RAI 03.07.02-29, Revision 1**QUESTION:**

RAI from Section 3.7 Audit, October 2010

REVISED RESPONSE:

**Figure 03.07.02-29.37: Comparison of Spectra – Base Mat
X-Direction**

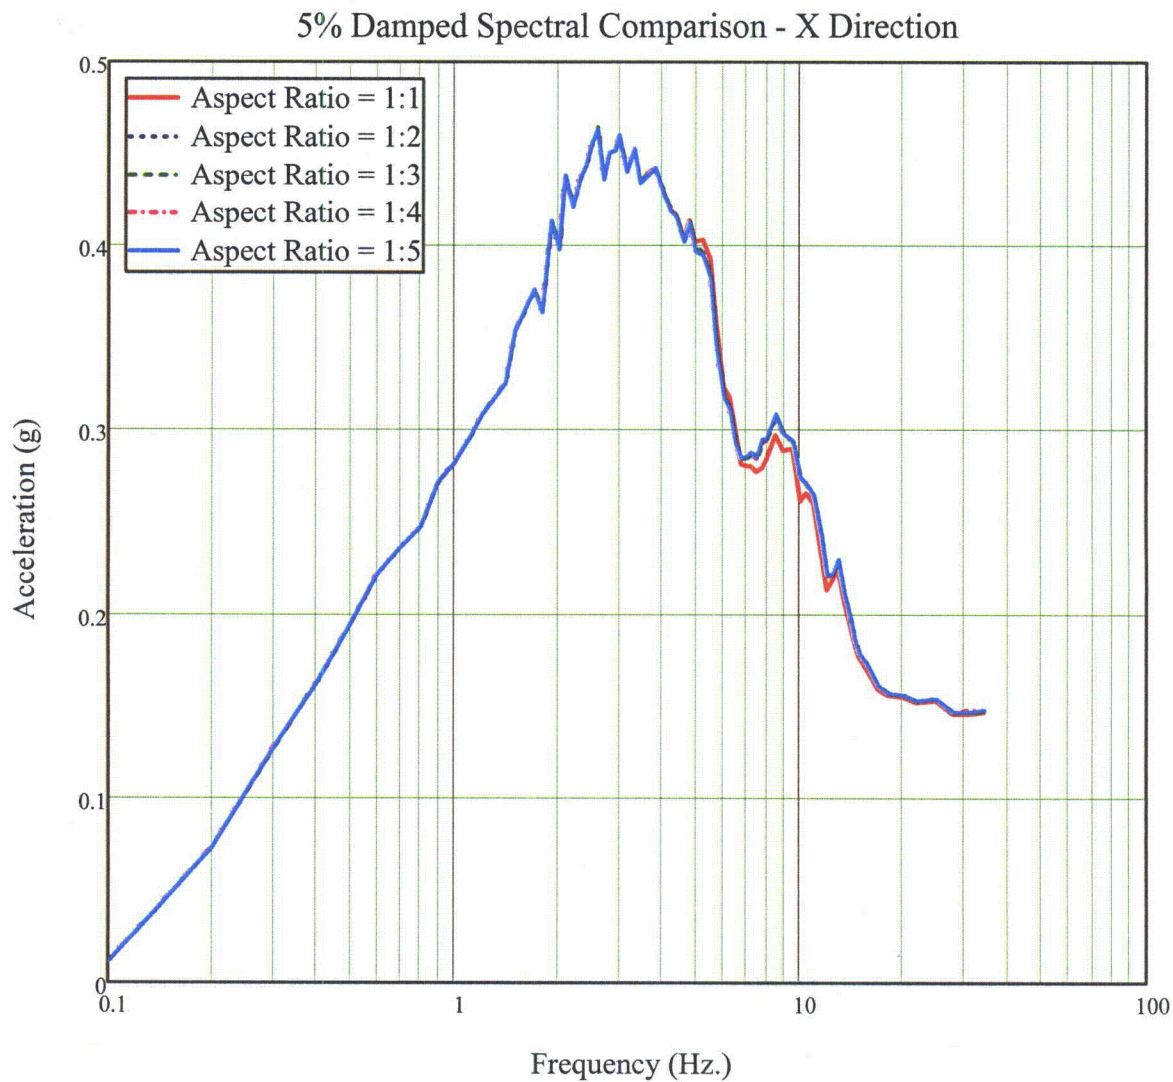
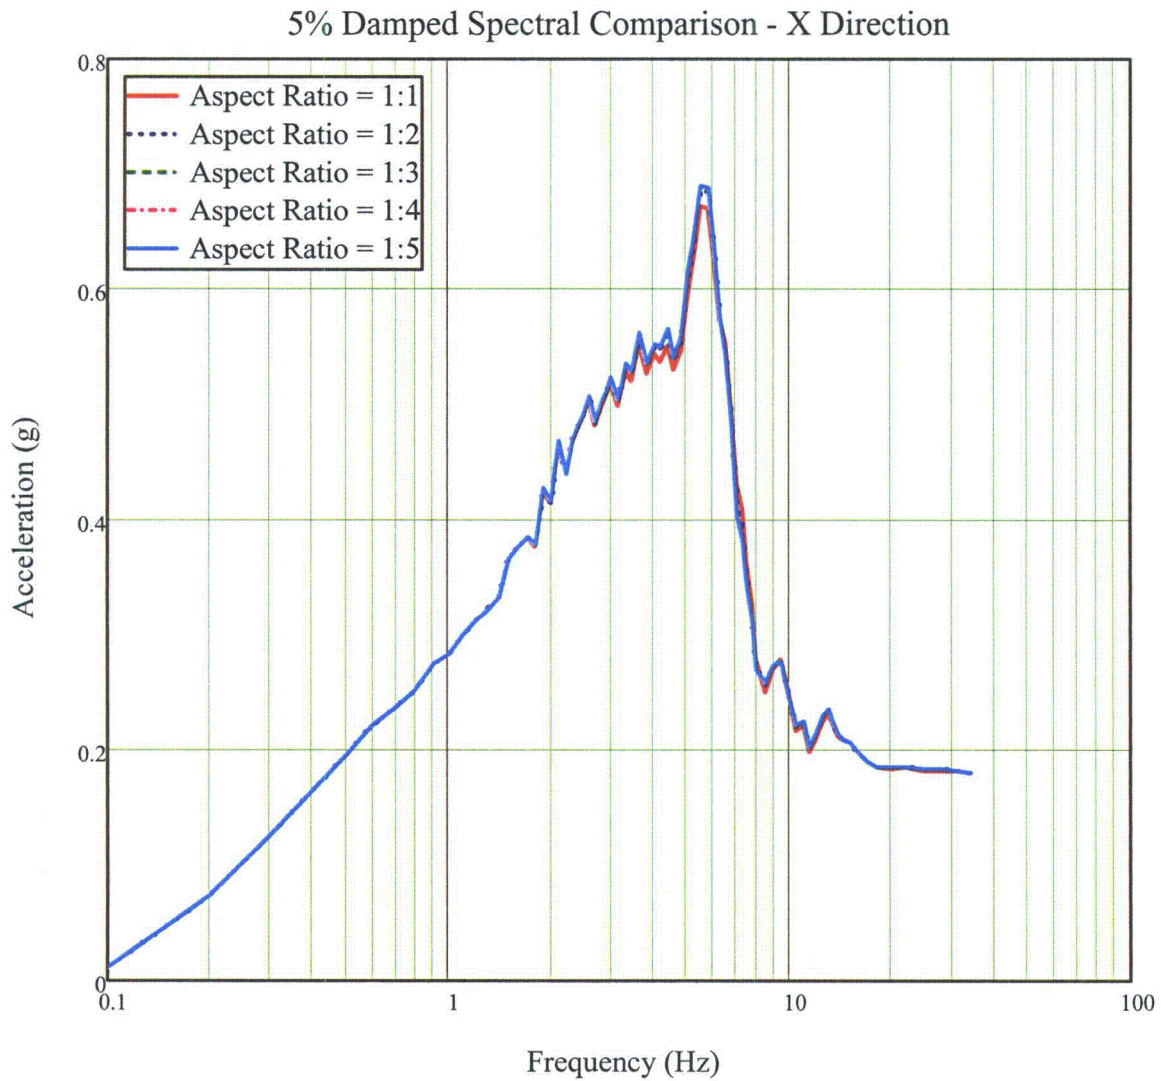
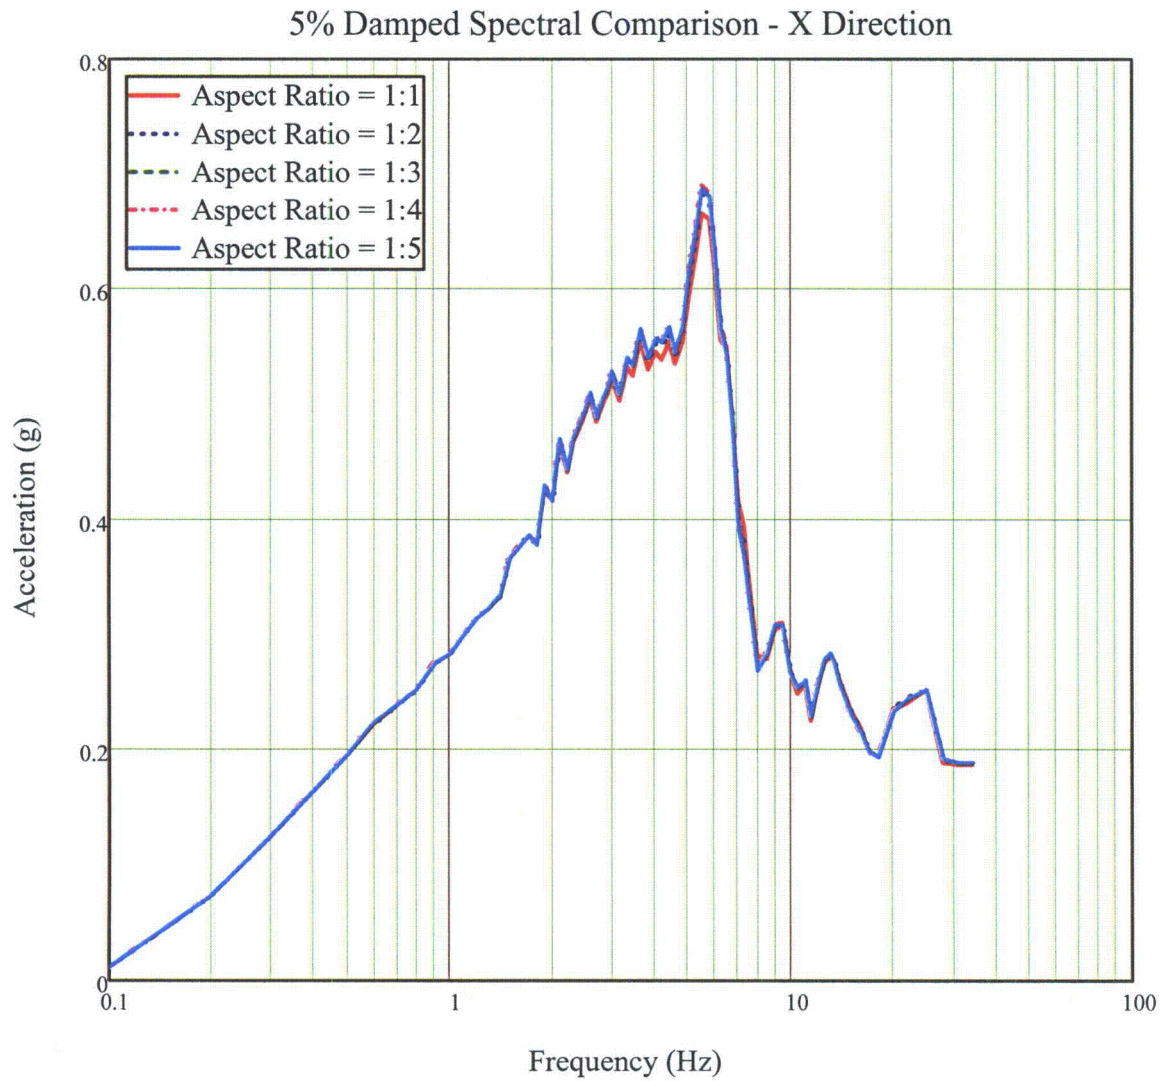
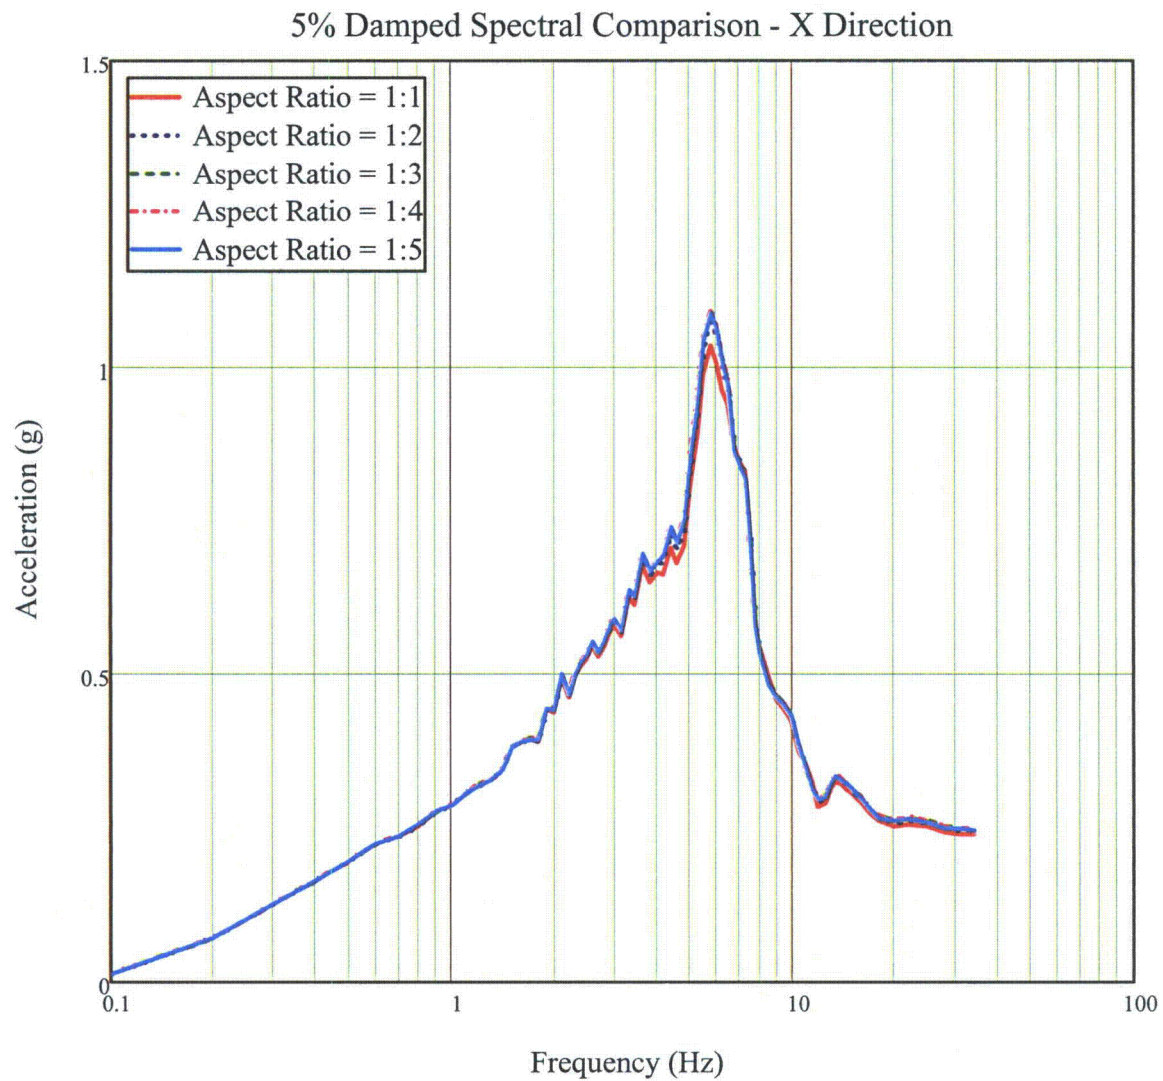
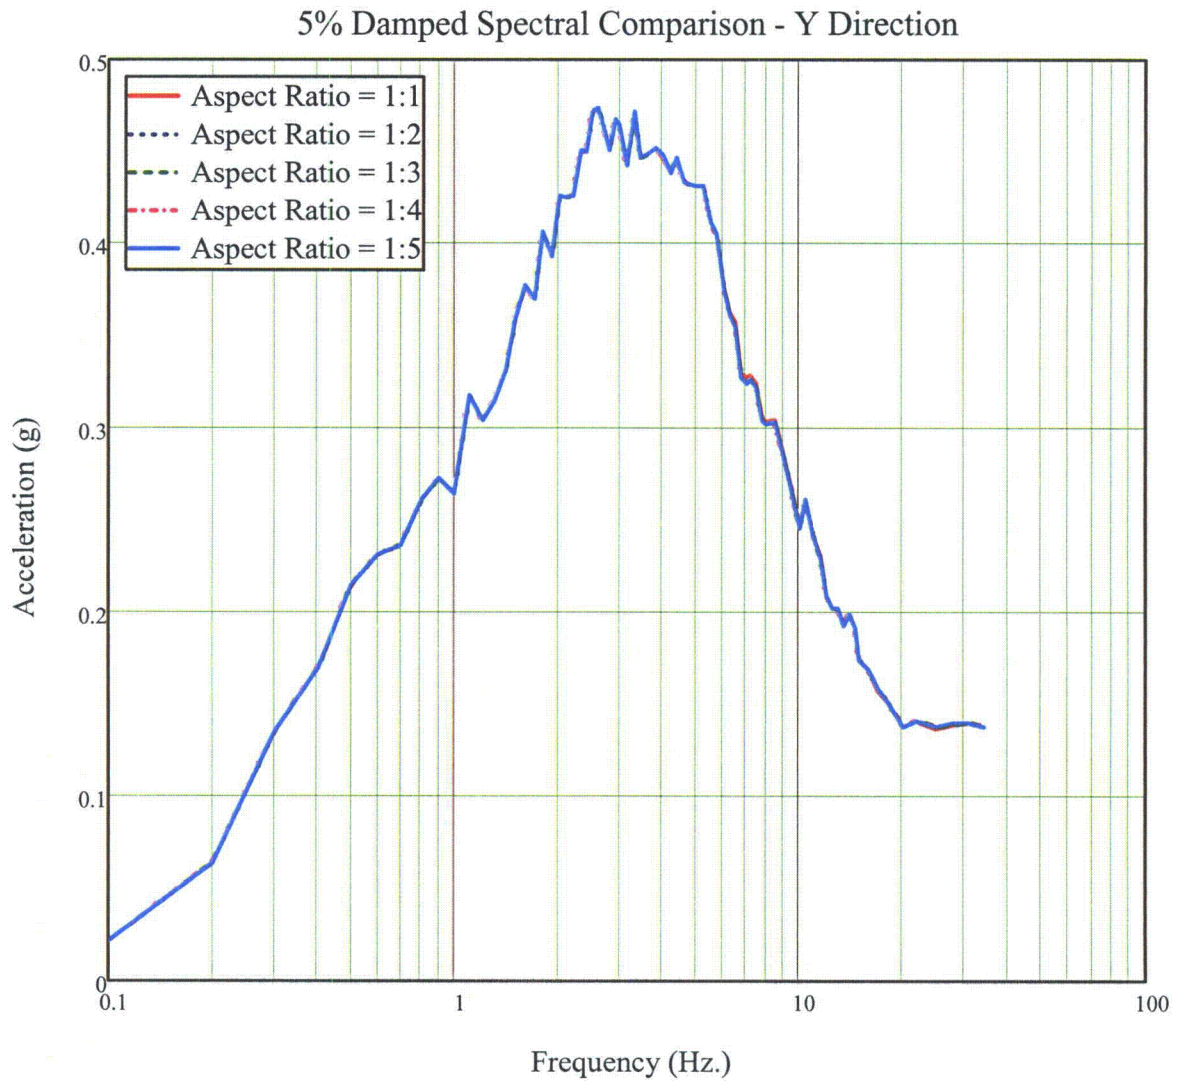
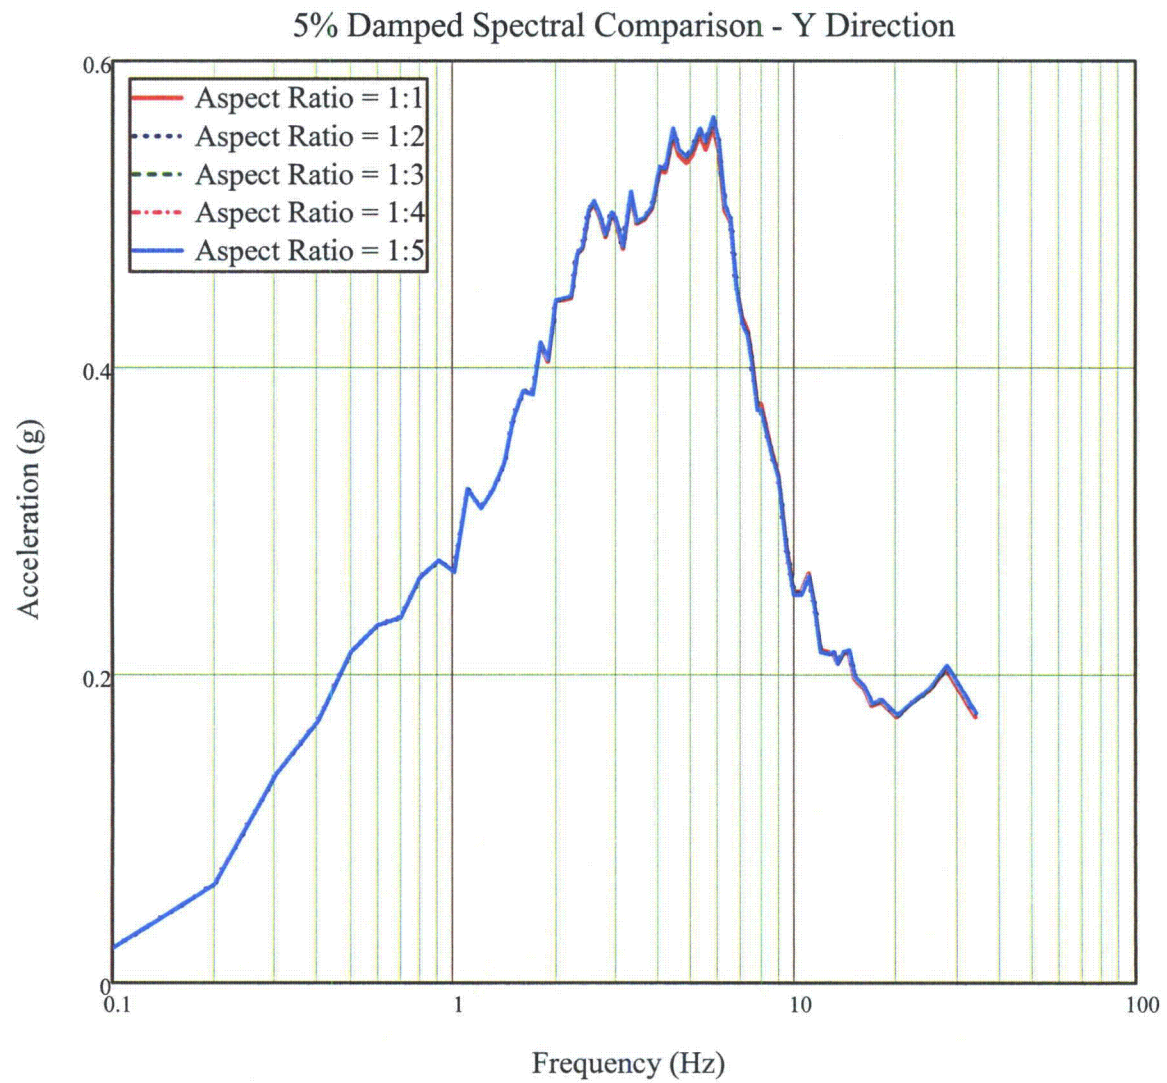
- **Acceptable aspect ratio of rectangular elements (solid, shell and plane-strain) to obtain accurate results, as used in the models**

Figures 03.07.02-29.37 through 03.07.02-29.40 show the comparisons of X direction 5% damped in-structure response spectra due to the X direction excitation, for various aspect ratios models, at various locations of the structure. The comparisons show that the response spectra compare well for aspect ratios up to 1:5.

Figures 03.07.02-29.41 through 03.07.02-29.44 show the comparisons of Y direction 5% damped in-structure response spectra due to the Y direction excitation, for various aspect ratio models. The comparisons show that the response spectra compare well for aspect ratios up to 1:5.
